## **MONTLIMAR OFFICE PARK SUBDIVISION,** **RESUBDIVISION OF LOTS 6 AND 7**

APPLICATION NUMBER 2 DATE June 17, 2021

REQUEST Subdivision

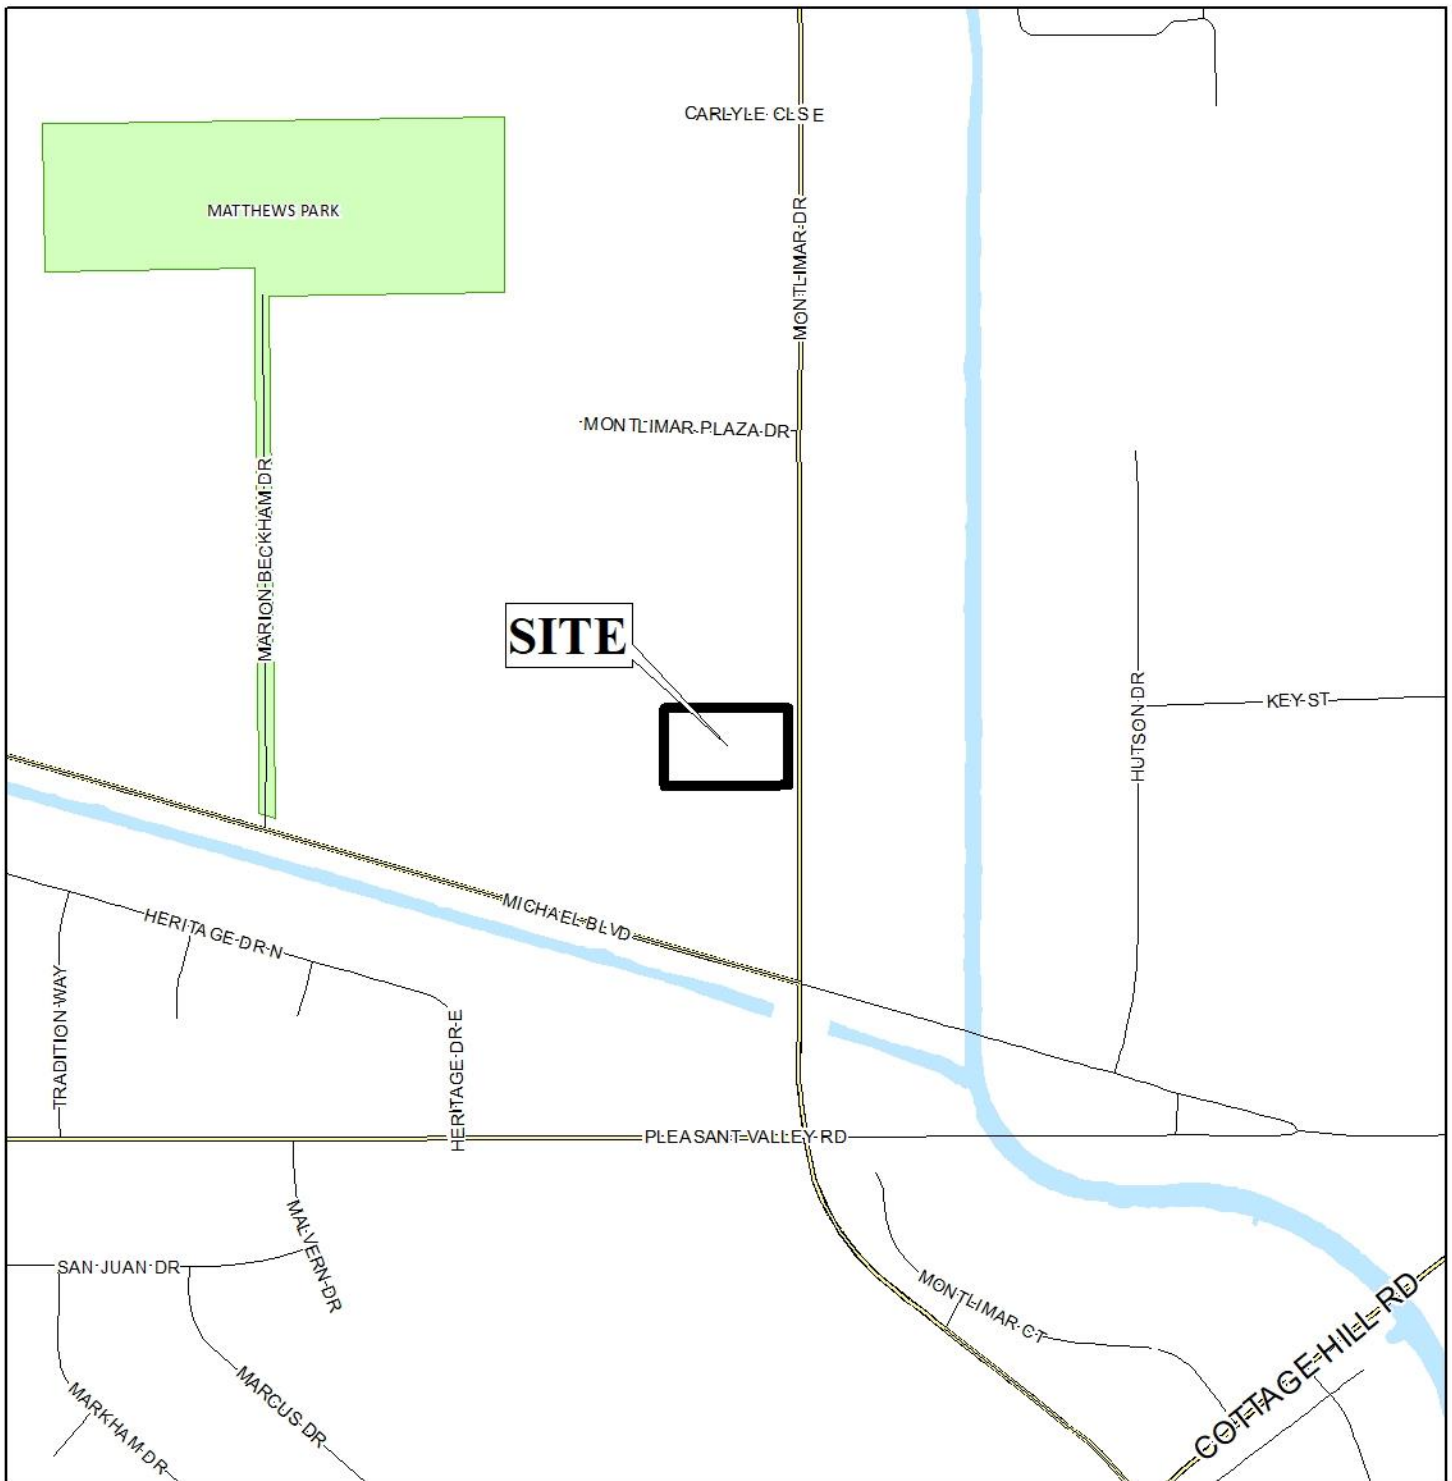
The site has frontage along Montlimar Drive, a minor arterial street per the Major Street Plan of the Map for Mobile. Previous subdivision of the site required an 80' right-of-way, as depicted on the preliminary plat, thus no additional dedication is required.

The proposed lot exceeds the minimum size requirements of the Subdivision Regulations for lots served by public water and sanitary sewer systems, and is appropriately labeled in square feet and acres in a table on the preliminary plat. If approved, this information should be retained on the Final Plat.

The 25' minimum building setback line is illustrated along Montlimar Drive, per Section V.D.9. of the Subdivision Regulations, and should be retained on the Final Plat, if approved.

Finally, two (2) easements are depicted on the preliminary plat: a 15' sewer easement along Montlimar Drive, and a 7.5' drainage and utility easement along the rear property line. If approved, a note should be placed on the Final Plat stating no structure shall be constructed or placed within any easement without permission of the easement holder.

- 1) Retention of the lot sizes in square feet and acres on the Final Plat;
- 2) Retention of the 25' minimum building setback line along Montlimar Drive;

- 3) Placement of a note on the Final Plat stating no structure shall be constructed or placed within any easement without permission of the easement holder;

# DETAIL SITE PLAN

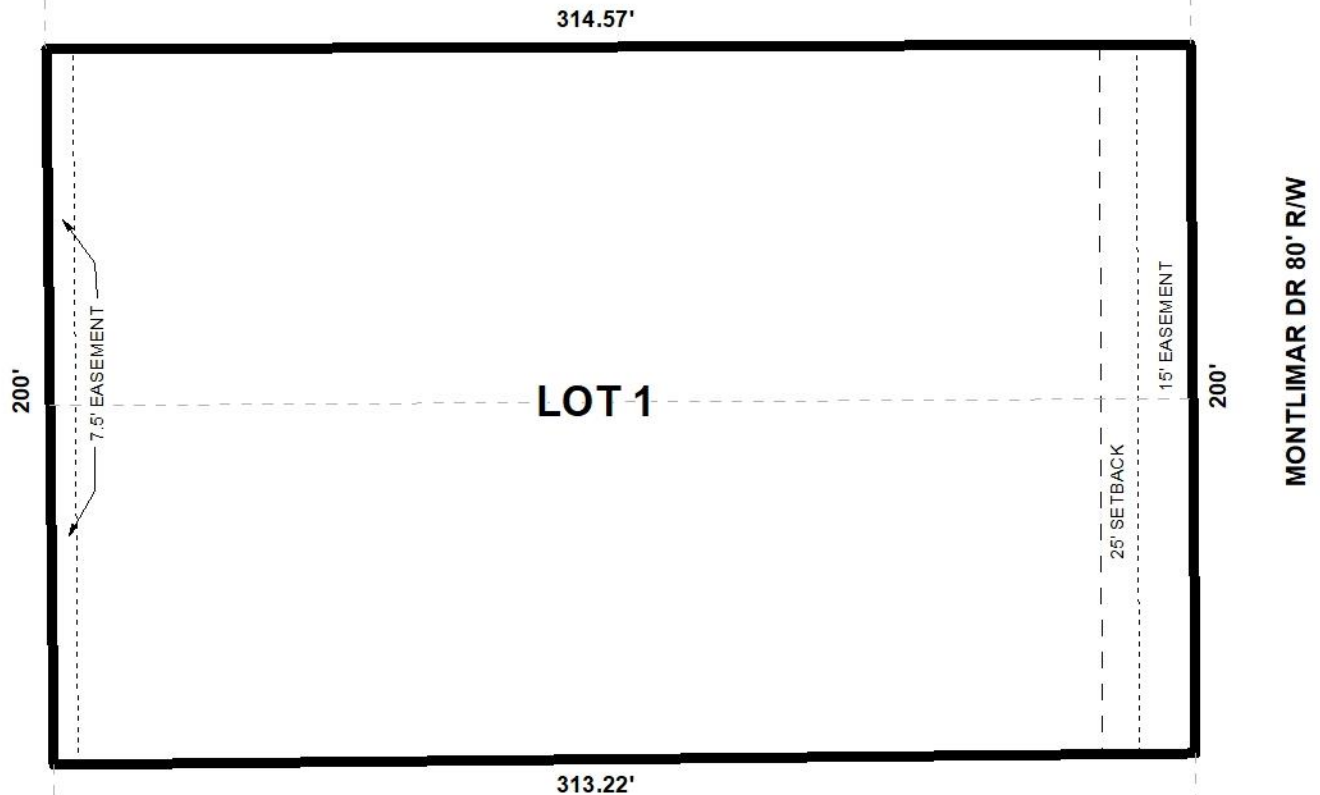
- B. Provide the Surveyor's and Owner's (notarized) signatures.
- C. Revise the labels for existing lot 6 & 7. The lettering is not legible.
- D. Add a note to the SUBDIVISION PLAT stating that as shown on the 1984 aerial photo (FLIGHT 24 - #79) LOT 1 will receive historical credit of existing (1984) impervious area towards stormwater detention requirement per Mobile City Code, Chapter 17, Storm Water Management and Flood Control) as follows: LOT 1 – NONE.
